service bulletin

TRACK-TYPE TRACTORS • NOVEMBER 18, 1955

STEERING CLUTCHES ¹²

STEERING CONTROL LINKAGE

FIGURE 1—Stacked height dimensions of the 11 steel discs and 12 steel disc clutch assemblies. Removal of one steel disc does not affect clutch capacity.

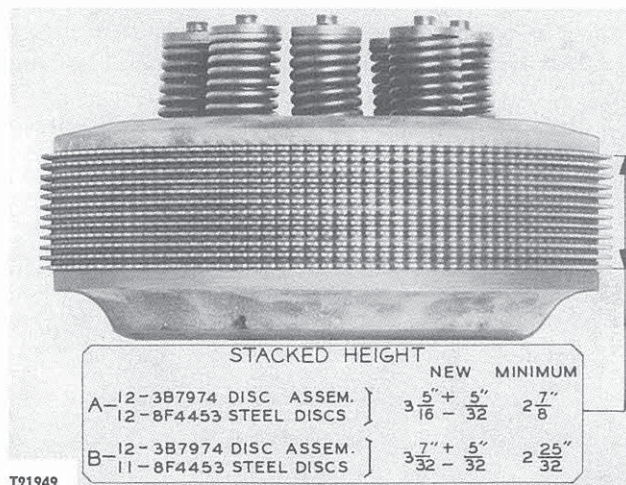
Steering clutch assemblies on these machines contained twelve 3B7974 Disc Assemblies and twelve 8F4453 Steel Discs. The 8F4453 Steel Disc assembled next to the 3H3718 Hub Assembly (pressure plate) has occasionally warped, causing clutch drag. Removal of this steel disc does not affect clutch capacity.

Effective with D8 Tractor 13A2228, the steel disc next to the pressure plate was omitted in steering clutches assembled at the factory. Clutch assemblies now contain twelve 3B7974 Disc Assemblies and eleven 8F4453 Steel Discs with a 3B7974 Disc Assembly assembled next to the pressure plate.

When steering clutches of D8 Tractors 2U21513 and up and 13A1 through 13A2227 are reconditioned, the steel disc next to the pressure plate should be omitted. When steering clutches are reassembled, the total stacked height of the discs should be measured to assure that the correct num-

The total stacked height of twelve 3B7974 Disc Assemblies and eleven 8F4453 Steel Discs is $3\text{-}7/32'' \pm 5/32''$. If the stacked height of the discs measures less than $2\text{-}25/32''$, the 3B7974 Disc Assemblies should be replaced as the clutch may slip.

For clutches with twelve 3B7974 Disc Assemblies and twelve 8F4453 Steel Discs, the total stacked height is $3\text{-}5/16'' \pm 5/32''$. If the stacked height of the discs measures less than $2\text{-}7/8''$, replace the 3B7974 Disc Assemblies.

FIGURE 2—Wavy pattern on drive lugs does not affect clutch operation.

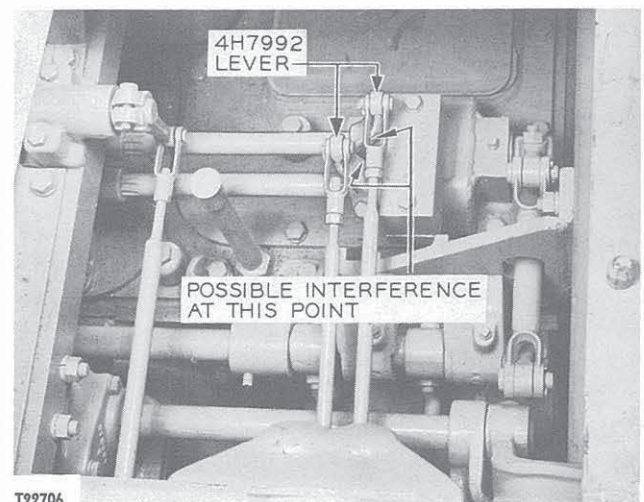
Service Reports and parts returned to the factory indicate that many steering clutch inner drums of the helical lug type used in D8 Tractors 2U21513 and up, 13A1 and up, Series D and E and No. 583 Pipelayers are being replaced unnecessarily. It appears that the wavy wear pattern which develops across the helical cut lugs has led servicemen to replace inner drums on the assumption that this would cause the clutch discs to "hang up", resulting in slippage.

This is not the case, since such wear patterns are normal and do not affect steering clutch capacity. The notches or steps produced are angled rather than square and do not hinder free engagement of the discs.

If inspection of steering clutch inner drums reveals wear such as that shown on the lugs, but the

drums are otherwise sound, the drums should be reinstalled. Care must be taken, however, to follow the correct assembly procedure. If the same discs are to be reinstalled, their positions in the stack can be rearranged to provide better wear distribution. Each disc must be installed with the same face up as was used in the previous assembly.
